STRUCTURAL EVALUATION OF MAGLEV GUIDEWAY CONCEPTS

ABSTRACT: The National Maglev Initiative (NMI) resulted in four distinctly different concepts. The structural systems of the concepts varied greatly, but in general were very complex. This paper evaluates the concepts as to their performance of selected criteria: constructability, reliability, maintainability, adaptability, and durability. Three of the systems used precast, prestressed concrete for the main load-carrying element. One system used aluminum. Only one system, system concept design (SCD-1) could be readily produced in existing precasting plants. None of the systems provided for easy adjustment of operating elements after construction. These systems require construction tolerances that are much more restrictive than conventional practice. Among the stated goals of the NMI concepts were: (1) it should anticipate upgrade; (2) it should be economically and financially attractive; and (3) it should be robust in terms of its susceptibility to adverse weather and its requirement for maintenance. This paper concludes that none of the four concepts adequately met these goals. However, some concepts could achieve the desired goal

FIG. 1. Concept SCD-1—Typical Cross Section

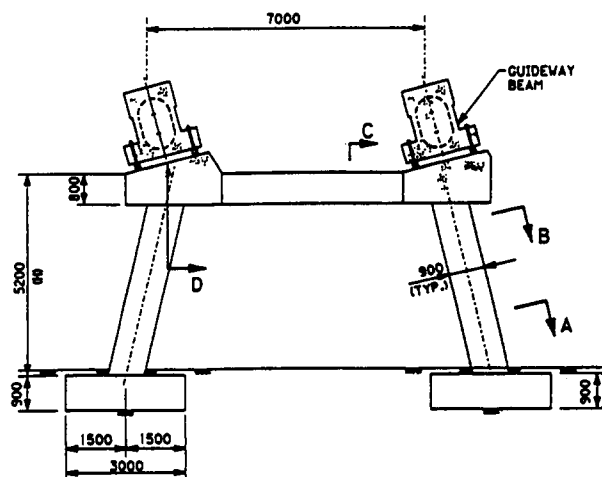
The proposed guideway shown in Fig. 1 is a precast, prestressed concrete box girder to which the levitation, propelling, and guidance systems are attached. It functions basically as a monorail. The typical span is 25 m (82 ft). The substructure is reinforced concrete supported on spread footings.

For constructability this concept has merit. The guideway of prestressed concrete could be produced by existing precasting plants. The substructure is a common type. However, there are serious concerns about the use of concrete end lugs cast integral with the guideway and the use of end blocks. These items greatly complicate the fabrication. If these deficiencies are corrected and if the length of the element is limited to the typical span (25 m), then the concept meets the criteria.

For reliability this concept appears to meet the criteria. However, the relatively long span, 25 m (82 ft), of the basic guideway raises questions about the amount of differential deflections due to creep of the prestressed concrete. Also, the

FIG. 2. Concept SCD-1, Detail of Structural Element: (a) Elevation; (b) Section B-B; (c) Section A-A

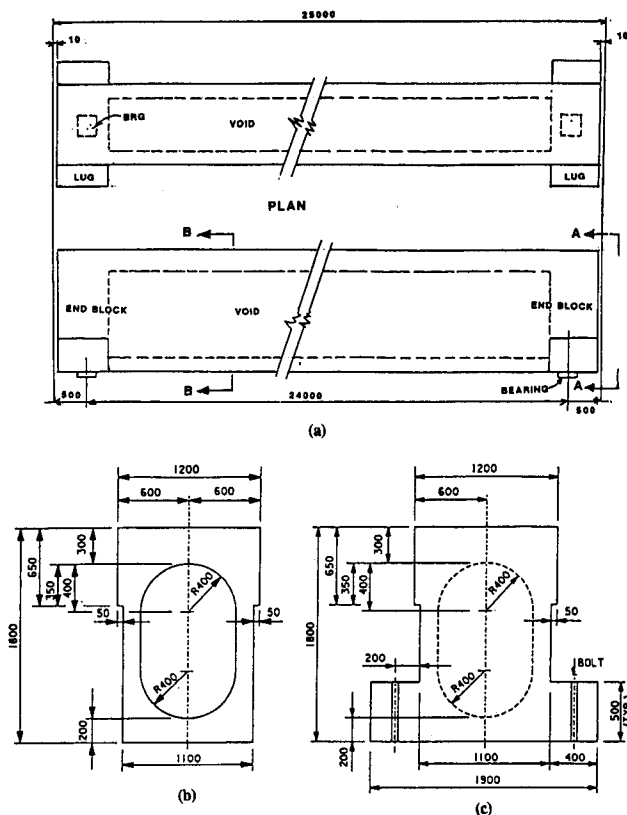
The apparent design philosophy is to incorporate the direct load-carrying element into the main structural element. This produces a compact section for typical spans, but does not address the need for longer spans over major streams. Use of standard bridge elements was not considered. Need for adjustment in the field was not sufficiently addressed. Details of the structural element of the guideway are shown in Fig. 2. Details of the magnet attachment are shown in Fig. 3.

FIG. 3. Concept SCD-1—Attachment Detail, Driving Element

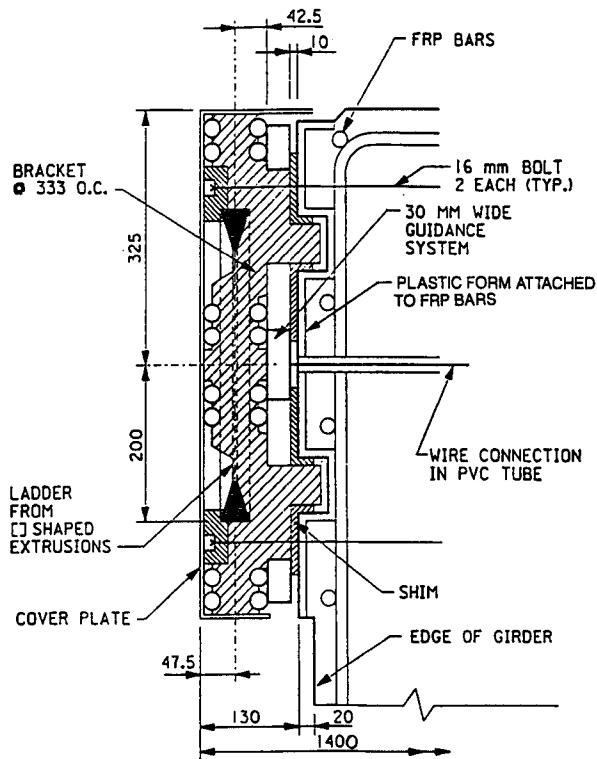
For maintainability this concept needs significant modifications. The attachment of the driving and guidance elements to a plastic form (Fig. 3) cast in the guideway allows very little adjustment. In addition, this adjustment is inaccessible and would require unmounting of the elements. The long length of the straight guideway, 25 m (82 ft), requires a horizontal offset of 13 mm (0.5 in.) on a 3,200 m (2 mi) radius curve. This is additive to the other construction tolerances that require adjustment.

For adaptability this concept needs modification. The 25 m (82 ft) long standard guideway weighs over 100,000 kg (112 t). This would require special equipment to handle or transport any replacement section. The method of attachment of the driving and guidance elements precludes their replacement with improvements that are sure to be developed. The optimum method of changing elements would be to replace each 25-m section together with the modified elements.

FIG. 4. Concept SCD-2—Typical Detail of Structural Element

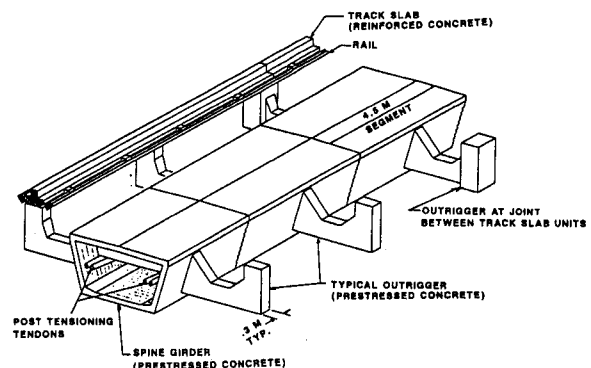
The proposed guideway shown in Fig. 4 consists of two rails that are suspended from brackets attached to a reinforced concrete track slab. The slab is in turn supported by posts spaced at 4.5 m (14.8 ft). The posts are an integral part of a precast outrigger that extends on each side of a segmental concrete box girder. The basic girder span is 27 m (88.5 ft). The girders rest on cast-in-place concrete piers, which are supported by piles.

For constructability this concept has many points of difficulty. The design of the guideway requires segmental construction of an unusual shape. The basic concrete box girder segment has an interior diaphragm and exterior cantilevers. The length of each segment is 4.5 m; the overall width is 4 m; and the height is 1.8 m. The main reinforcement of the cantilevers is a draped posttensioning strand. These segments would be

For reliability this concept has many weaknesses. The cantilevers produce a torsional load on the box girder. Deflections due to this torsion are additive to the deflections due to the gravity load of the vehicle. Deflections due to temperature differentials in the box girder must also be considered.

Overall this concept, at the present stage of development, needs significant modifications. However, if the track slab were supported on an independent structure, built of commonly used elements, it could be workable.

FIG. 5. Concept SCD-2, Post-Tensioning Details: (a) Section A during Initial Installation; (b) Section B during Initial Installation; (c) Section A during Tendon Restressing; (d) Section B during Tendon Restressing

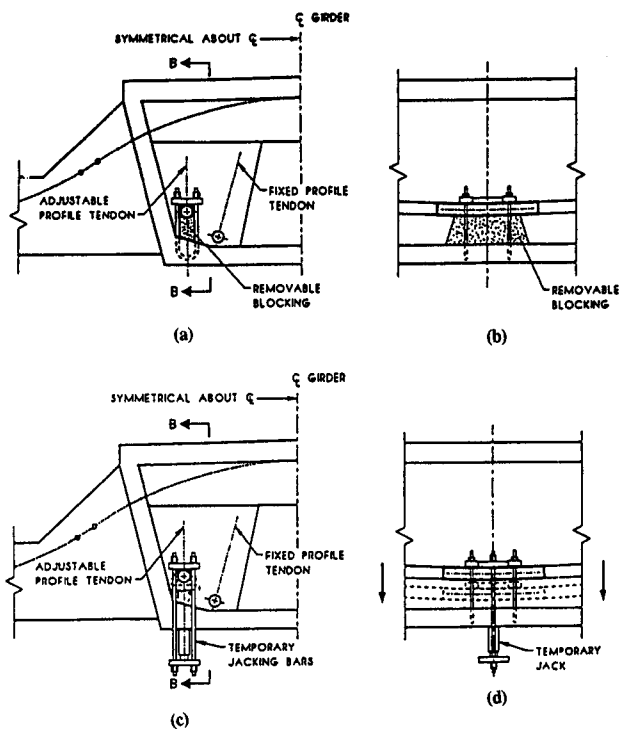
difficult to fabricate and to transport. The posttensioning elements of the box girder are external strands located inside the box girder. A special device shown in Fig. 5 is provided to permit restressing of the tendons. This increases the field labor. In summary, this concept uses minimum material, but is very labor intensive both shop and field.

FIG. 6. Concept SCD-2—Track Slab Details

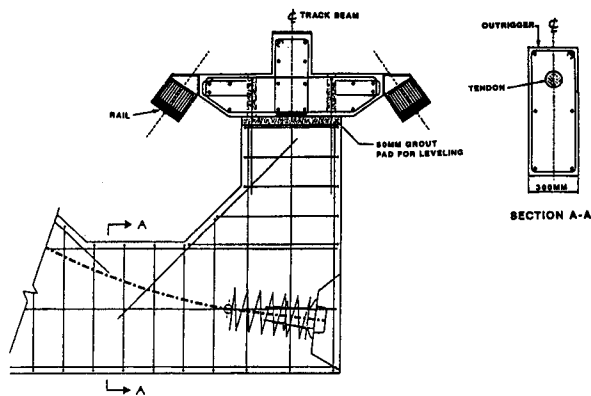
Depending on the operational tolerances of the vehicle suspension system, these deflections could produce a less than desirable ride. A detail of the track slab that is supported on the cantilevers is shown in Fig. 6. The entire load of the vehicle is transferred to the track slab by steel brackets spaced 2.25 m apart. Details of these brackets were not clearly shown, but they represent critical connections. They function in shear and tension and must be attached to the edge of the track slab, which is only 120 mm deep.

cations. The only adjustment, other than that provided by restressing the main posttensioning strands, is a 50-mm grout pad provided on the top of the cantilever post shown in Fig. 6. Once the track beam has been adjusted to the right position, this grout is placed and set. After that adjustments would require demolition. Provisions for adjustment of individual track beams were not shown.

For adaptability this concept also needs significant modifications. As cited in maintainability, once the guideway is completed there is no opportunity to change or replace any individual track beam without demolition.

FIG. 7. Concept SCD-3—Typical Cross Section

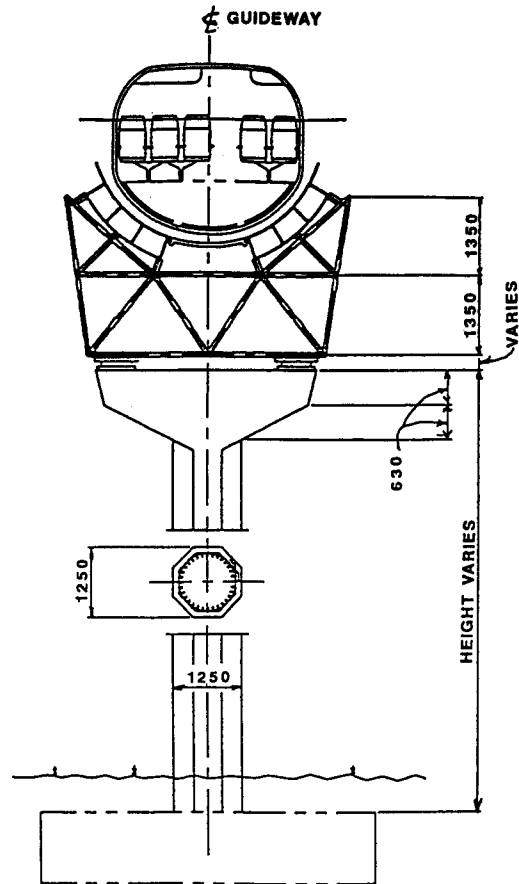
The proposed guideway shown in Fig. 7 consists of two aluminum structures, forming a trough, curved to fit the shape of the vehicle. These structures typically span 9.14 m (30 ft), but could span 13.72 m (45 ft) or 18.29 m (60 ft). Where longer spans are needed, an aluminum structure spanning 4.57 m (15 ft) would be supported on a steel or concrete framework. The substructure is reinforced concrete supported on spread footings or piles.

Standard construction elements for highway and railroad bridges were not selected to support the troughs. Instead, unusual trusses and box girders are indicated.

For constructability this concept needs an in-depth study. Welded aluminum sections require highly specialized fabrication techniques. Fabrication of curved box beams from thin plates is very difficult. Providing adequate support for the box beams is field labor intensive. Tolerances would be difficult to meet.

For reliability this concept also needs further study. During operation, the levitation plate could experience a 180°C (325° F) rise in temperature due to the frequent passage of vehicles. Since the levitation plate is an integral part of the curved box beam, there will be serious temperature strains that could cause deformations and large stresses in the guideway. The proposed expansion joint shown in Fig. 8 relies on the bearing of the levitation plate on a backing plate. This detail has no provision for these deformations.

FIG. 8. Concept SCD-3—Expansion Joint Detail

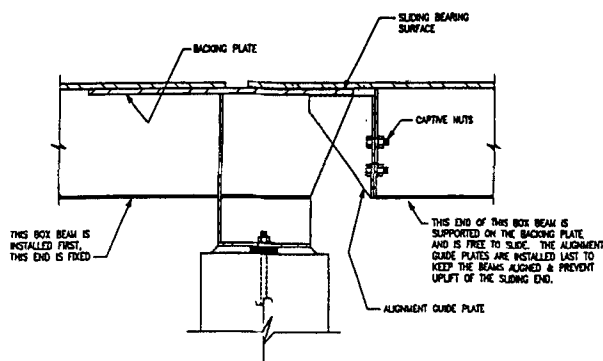
For maintainability this concept would be difficult. The interior of the box beam is inaccessible for inspection and maintenance. Also as shown in Fig. 8 there will be uneven and highly concentrated wear on the levitation plates due to temperature movement, and hence more maintenance. On the plus side, the large gap between the vehicle and the surface of the

For adaptability this concept is limited. Any future improvements that would require dimensional changes in the vehicle or guideway could be extremely difficult to install. The ability to replace a faulty guideway element with another element is restricted. This is particularly true at the proposed expansion joint.

For durability this concept is uncertain. The extensive use of aluminum, particularly in curved thin plates, has a potential of becoming deformed due to high temperatures and secondary stresses. The wear at the expansion joint could severely limit the life of an element. Aluminum has a low fatigue threshold and therefore must be designed for a very low service load stress to achieve a reasonable service life.

FIG. 9. Concept SCD-4—Typical Cross Section

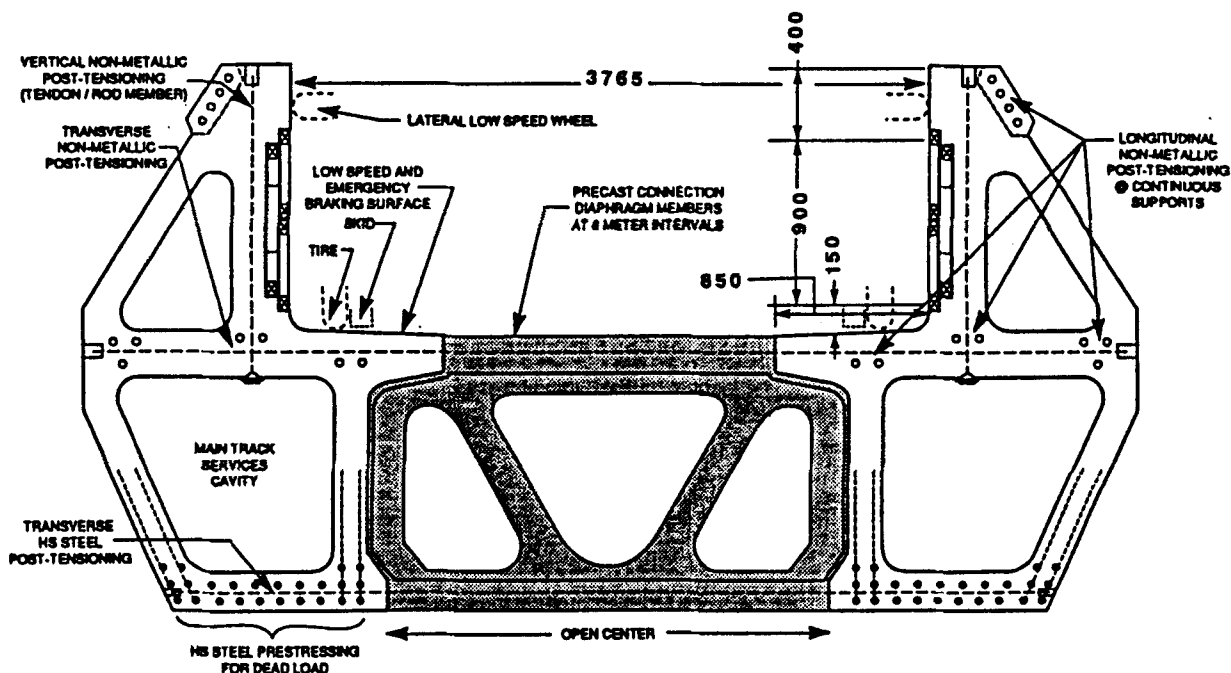
The proposed guideway shown in Fig. 9 consists of a pair of double voided precast, prestressed concrete box girders. These are connected with precast, trussed diaphragms spaced 6 m (19.7 ft) apart. The girders and diaphragms are posttensioned together. The stated philosophy is that, in large measure, economy will be achieved by a selection that minimizes the quantities of structural materials used. This is contrary to the writers' experience that minimizing field labor, simplifying details, and eliminating as many operations as possible are the best way to address economy. The typical span is 27 m (88.6 ft). The substructure is a single leg hammerhead pier on spread footings.

For constructability this concept needs significant modifications. The unusual, nonsymmetrical shape of the guideway elements is very difficult to form and cast. The odd shaped diaphragms spaced 6 m apart makes erection very difficult. The guideway elements cannot be placed in position before installing the diaphragms. There are 432 transverse and vertical glass fiber, reinforced plastic posttensioned (GFRP) bars for every 27-m span. This is very field labor intensive.

tions. There are many weak points in this very complex structure that could develop flaws. This is particularly true of the many GFRP strands. Repair of this weak point is very difficult.

For maintainability this concept needs further study and development. There are no provisions for adjustment of the elements of the guideway. Details of end diaphragms for bearings were not shown. However, access to the voids for inspection would be very difficult. There is a need to periodically check the GFRP posttensioned strands to ensure adequacy of stress.

For adaptability this concept also needs further study and development. Because all elements are cast integrally, there is no provision for changing or replacing an element. The entire guideway would have to be changed.

For durability this concept needs an in-depth study. The extensive use of GFRP is a concern. Its long time performance is not proven. The complex shapes are certain to induce secondary stresses, which may be detrimental.

Overall this concept, at the present state of development, raises many questions. However, if the structural elements to which the levitation, propulsion, and guidance systems are attached were separated from the main carrying member the concept could be a workable one.
